# UNITED STATES PATENT AND TRADEMARK OFFICE

APPLICATION NO.	FILING DATE	FIRST NAMED INVENTOR	ATTORNEY DOCKET NO.	CONFIRMATION NO.
10/697,989	10/31/2003	Toshio Tetsuka	SN-US035137	8968

<b>Office Action Summary</b>	<b>Application No.</b> 10/697,989	<b>Applicant(s)</b> TETSUKA, TOSHIO	
	<b>Examiner</b> William Windley III	<b>Art Unit</b> 3682

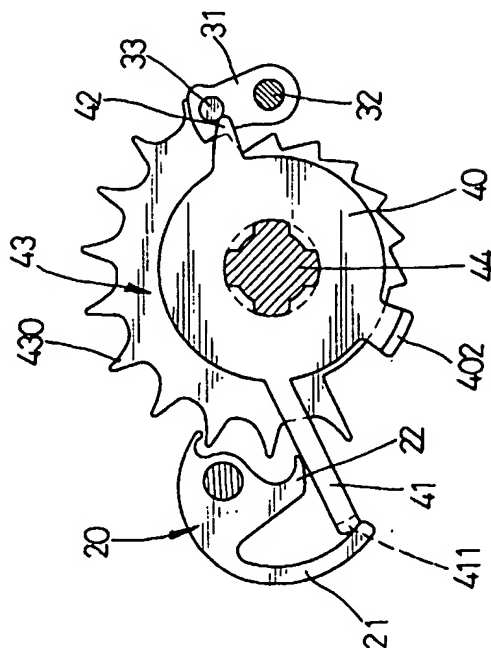
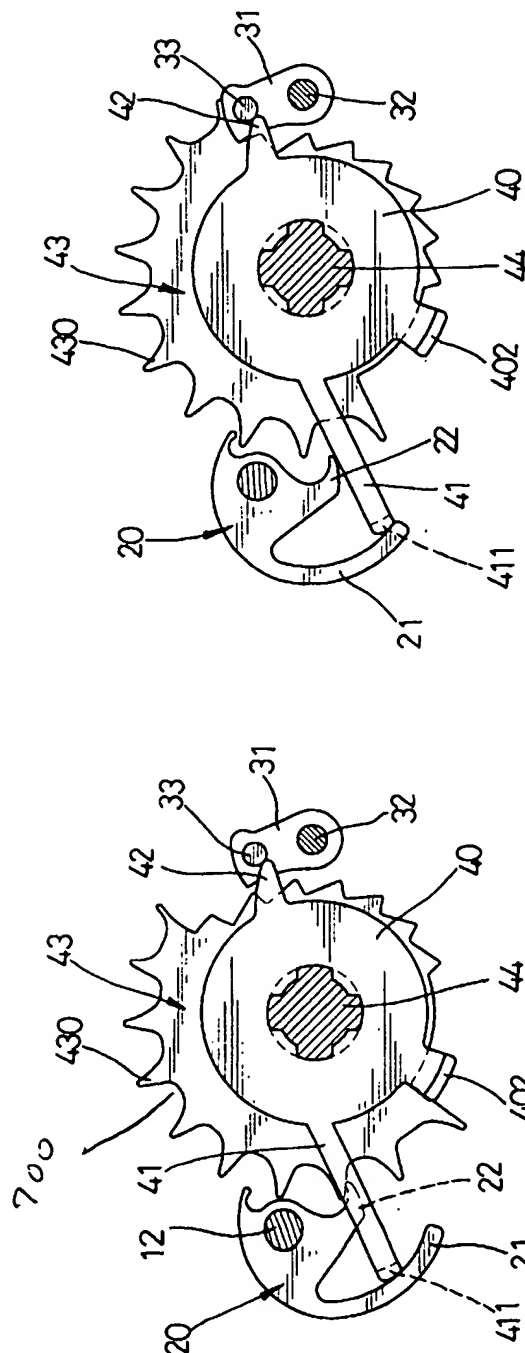
5. Claims 1-9 are rejected under 35 U.S.C. 103(a) as being unpatentable over Ueng  
USP 5957002 in view of Rivin USP 4184380.

Re claims 1-9 Ueng discloses a(n):

- Operator actuating member (10)
- Positioning mechanism including:
  - First member and second members (43,20)
  - Buffering member [430; tooth 430 buffers the fall and movement of 20  
(see Figure 5)]
- Recess (700, See Figure 3, marked by examiner)
- Ratchet element (43)
- Pawl element (20)
- Winding element (52)

But does not disclose a buffering member that is a coating.

Rivin teaches buffering elements (18) that are coatings for the purpose of reducing noise, vibration and wear and reduced sensitivity to distortions in gear alignment (Column 2, lines 35-37).

It would have been obvious to one of ordinary skill in the art at the time the invention was made to combine the setup of Ueng and employ a buffering element that is a coating, as taught by Rivin, for the purpose of reducing noise, vibration and wear and reduced sensitivity to distortions in gear alignment (Column 2, lines 35-37).
